RE: TRINITY STAGE 2 BUILD-TO-RENT HOUSING DEVELOPMENT
RESPONSE TO MATTERS RAISED BY AUTHORITIES

As requested, we are writing with regards to traffic and parking matters raised by Ryde City Council for the State Significant Development Application (SSD-55844212), for the Trinity Stage 2 Build-to-Rent housing development at 39 Delhi Road, North Ryde.

PRINCIPLES OF SERVICE
VEHICLE MANAGEMENT
PLAN

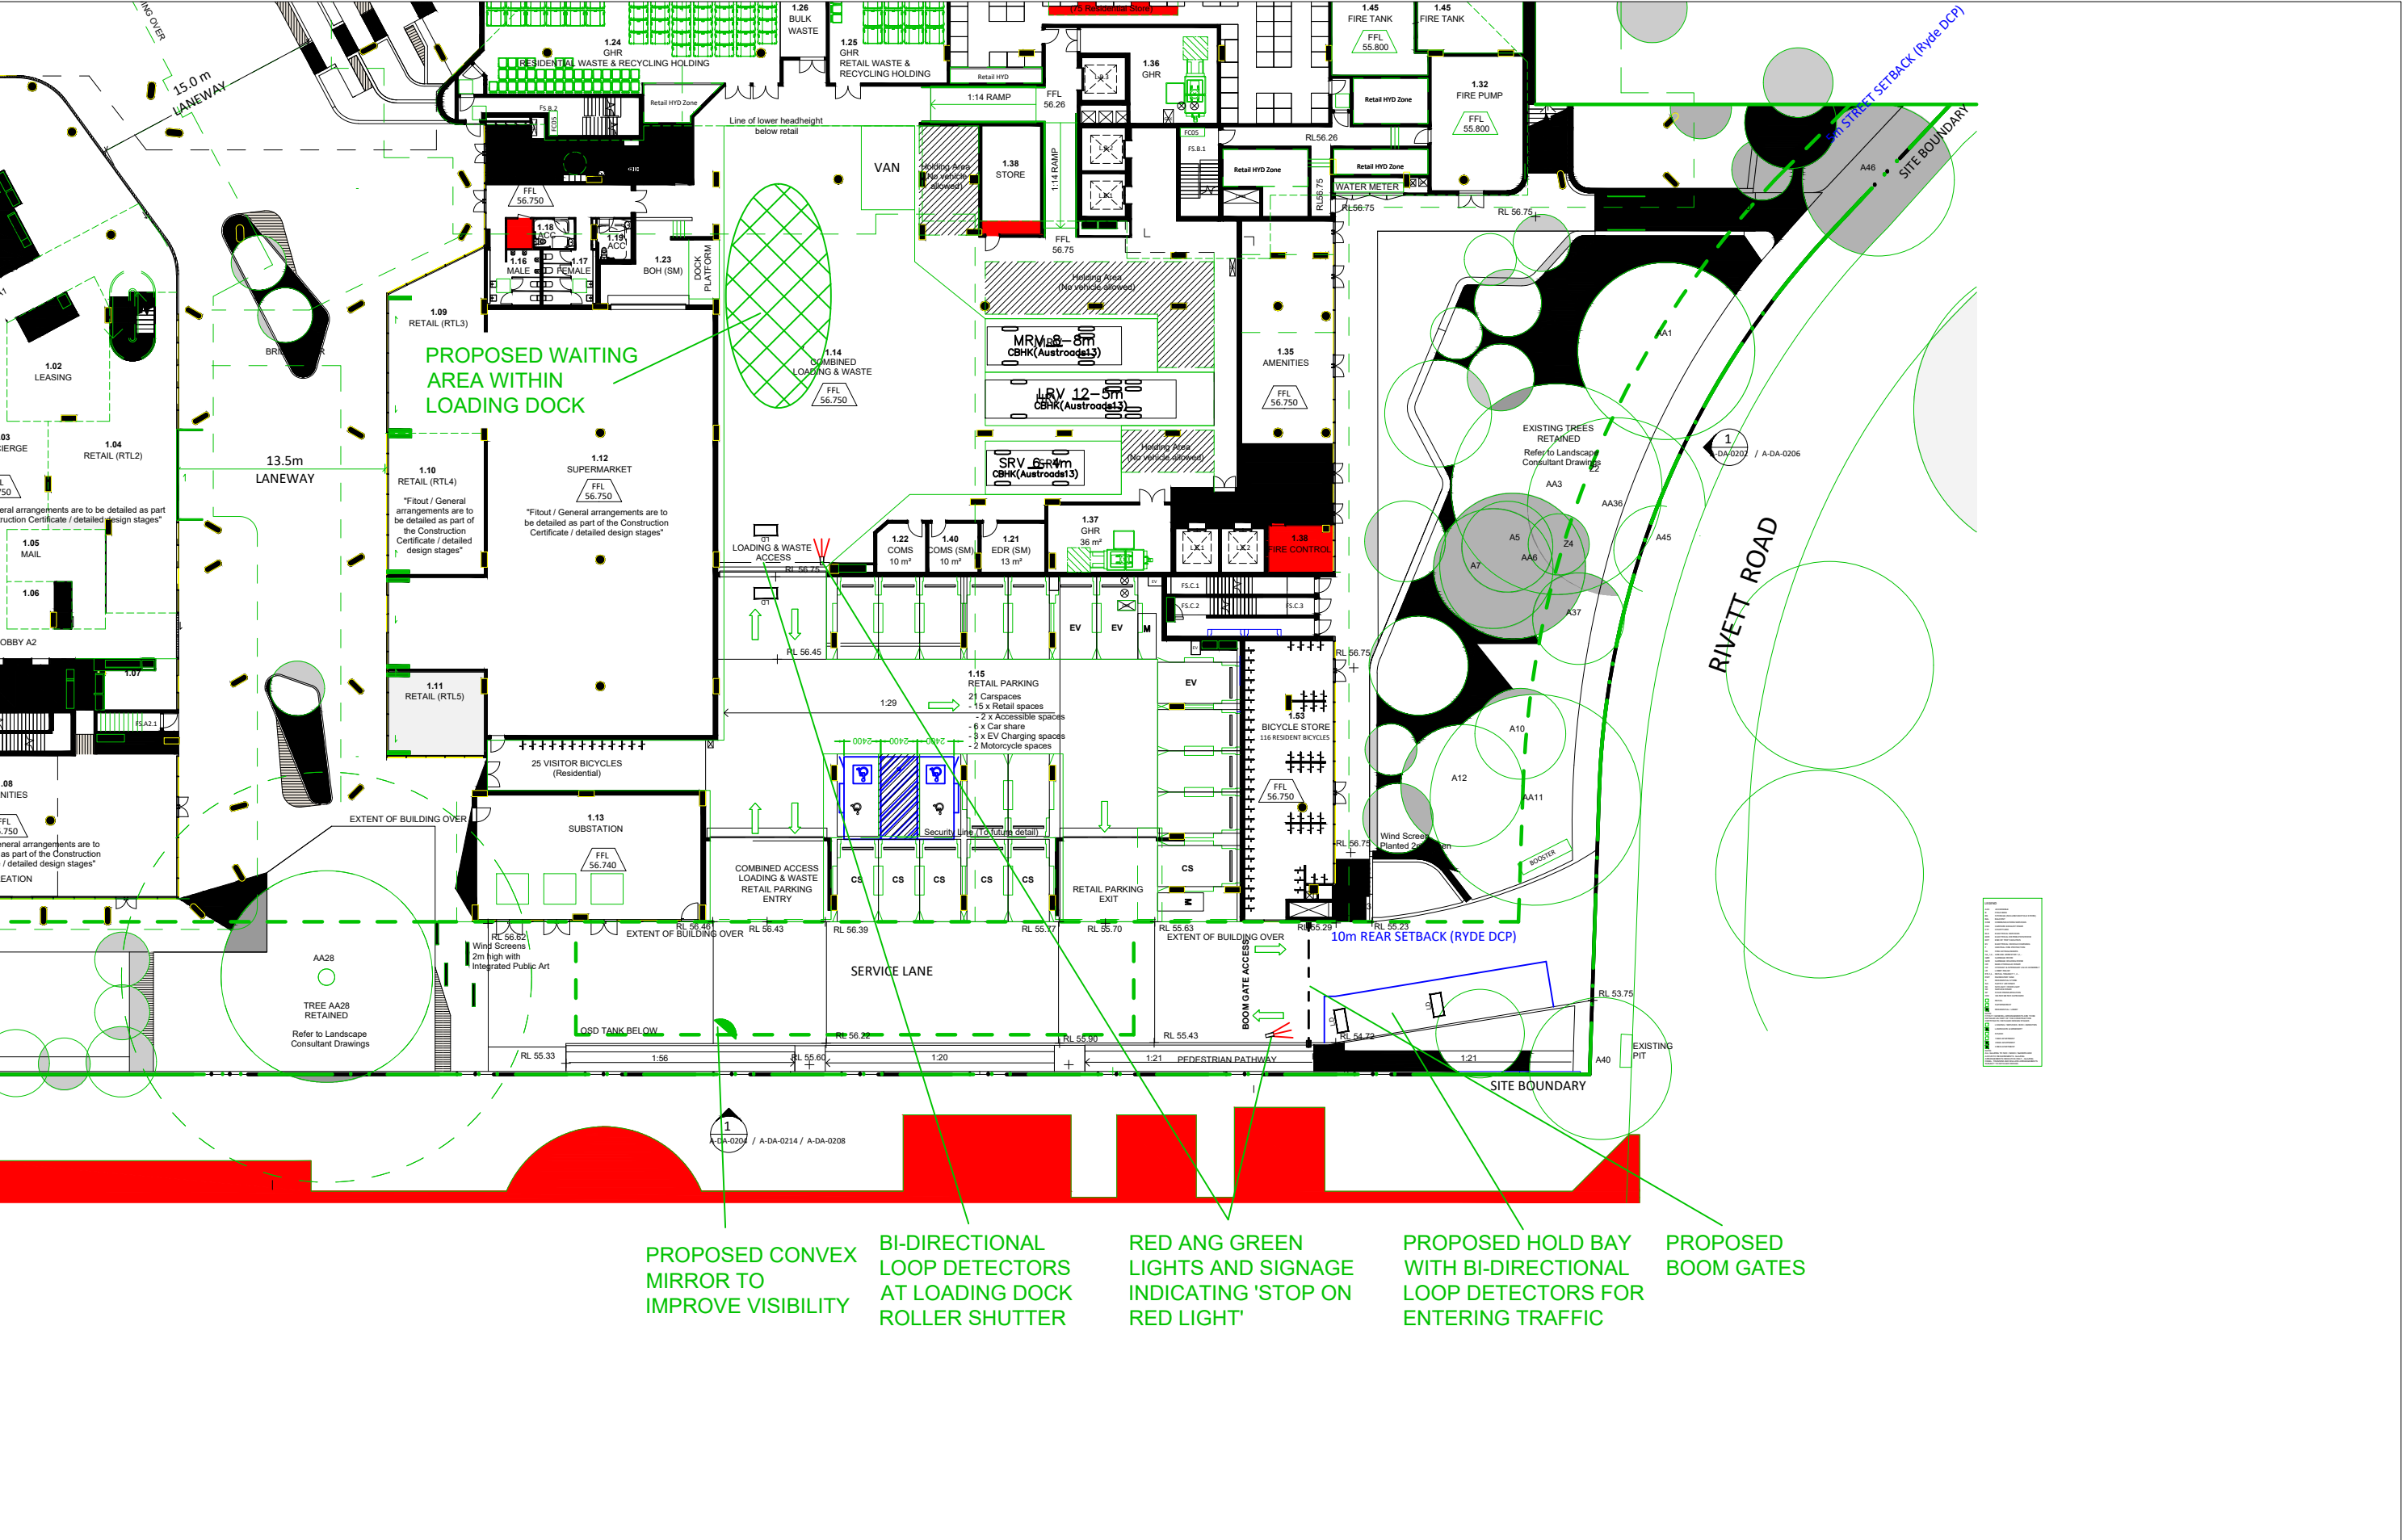
- *The applicant is to provide detail of the location of the waiting area/hold bay within the development site, location of the traffic signals and how the flashlight/signal system will work for the development. Please note, a hold bay or waiting bay within Council's land will not be supported. In addition, priority needs to be given to the exiting vehicle under the traffic signal/flashlight arrangement.*

- *The loading dock and driveway design does not permit more than one HRV on site at any time. If an HRV is already onsite, swept paths provided in the traffic management plan show that there is no holding location for any additional HRV onsite. As such a traffic management system is required at the driveway entrance at Rivett Road with an accompanying loading dock management plan.*

The loading dock will be managed via a Service Vehicle Management Plan (SVMP) which will be prepared prior to construction certificate. The SVMP will establish a traffic management system for the loading dock and adjacent retail car park, via the use of boom gates, hold bay for entering vehicles, active signage (stop within hold bay on RED signal), bi-directional loop detectors and lights located within the loading dock and on the internal service road, as shown on Figure 1. The traffic management system would include the following:

- boom gates will be located on the internal service road, within the site from Rivett Road;
- a hold bay will be located for entering vehicles, on approach to the boom gates;

- red and green lights will be located within the loading dock and on the internal service road, informing motorists and service vehicle delivery drivers when service vehicles are entering and exiting the site. The lights will set priority to exiting vehicles;

- the lights will be activated via the use of di-directional loop detectors located within the loading dock and on the internal service road;
- on arrival, retail customer vehicles and service vehicles will stop on the RED signal at the designated hold bay within the service road, clear of Rivett Road;

- the bi-directional loop detector within the service road will register the arrival of the vehicle, change the lights to GREEN for entering vehicles and open the boom gate;

- the entering vehicle will then proceed to the loading dock or to the adjacent retail parking area. The loop detectors within the loading dock (or after a period of 10 seconds) will reset the lights to exit priority;

- on exit, service vehicles exiting the loading dock or customer vehicles exiting the adjacent retail car park will proceed to the exit boom gate controls. The di-directional loop detectors on approach to the exit boom gate controls will open the boom gate and the vehicle will exit onto Rivett Road.

The loading dock has been modified to include a waiting area, as shown on Figure 1. The waiting area would be available for a service vehicle to stand, should the loading bays be occupied.

SERVICE VEHICLES ENTERING
AND EXITING AT THE SAME
TIME AS CUSTOMER VEHICLES

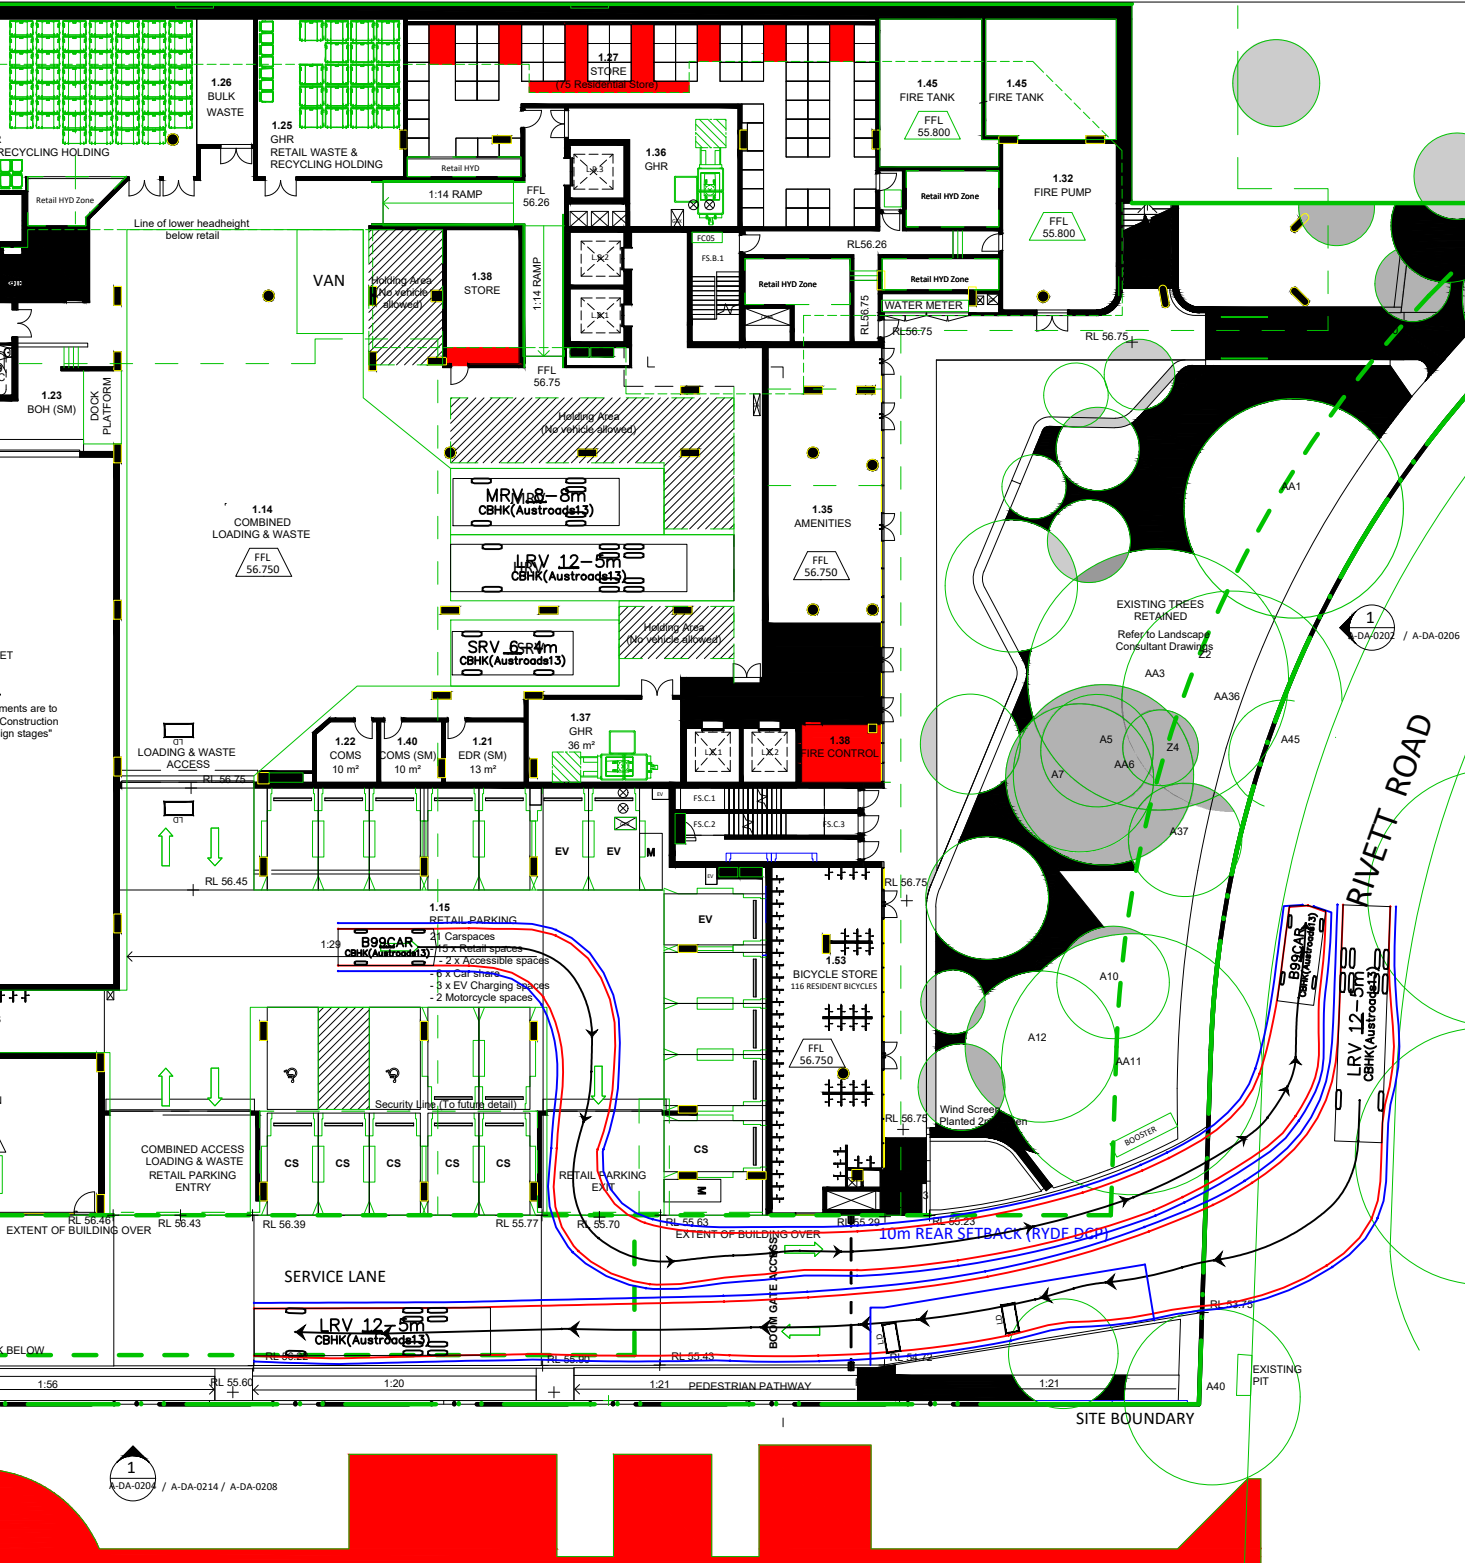
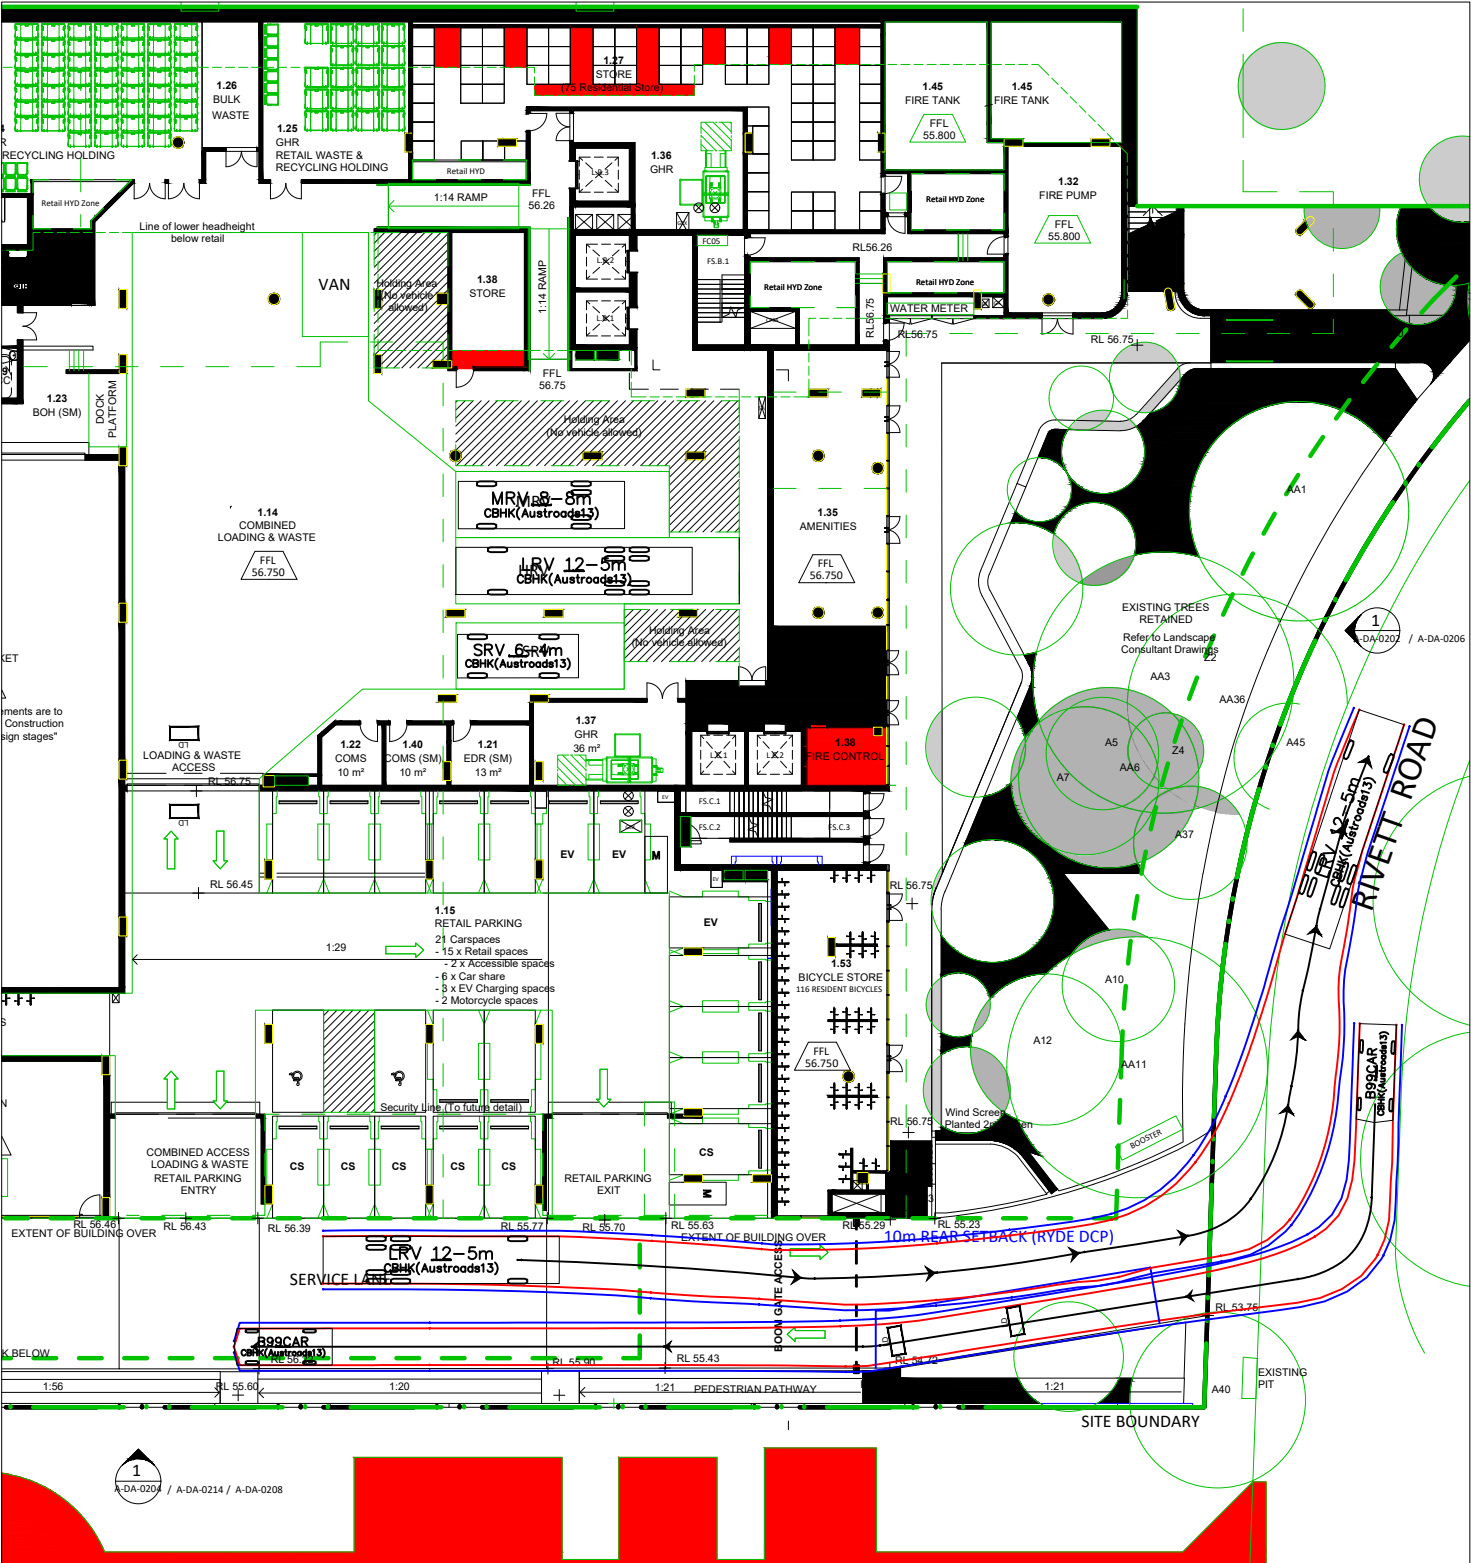
- *The swept paths (Appendix N - TALA, pgs 69-74) show multiple intrusions in the clearance to vehicle body envelope (which includes the mirrors).*
- *The swept paths show the HRV having to mount the pedestrian walkway at the south of the property to turn into the loading dock.*

- *The Transport and Accessibility report claims that there are multiple pullover opportunities for retail customer vehicles to wait for the HRV to pass – the swept paths provided for HRV access and HRV/B99 simultaneous access conflict.*

The service vehicle swept paths have been updated onto the latest architectural plans, as shown on Figures 2 to 5. The swept paths indicate that with the traffic management system in place, there will be no conflicts for entering and exiting vehicles.

The updated swept paths indicate that with the traffic management system in place, there would be no conflicts for entering and exiting vehicles, as shown on Figures 2 to 5.
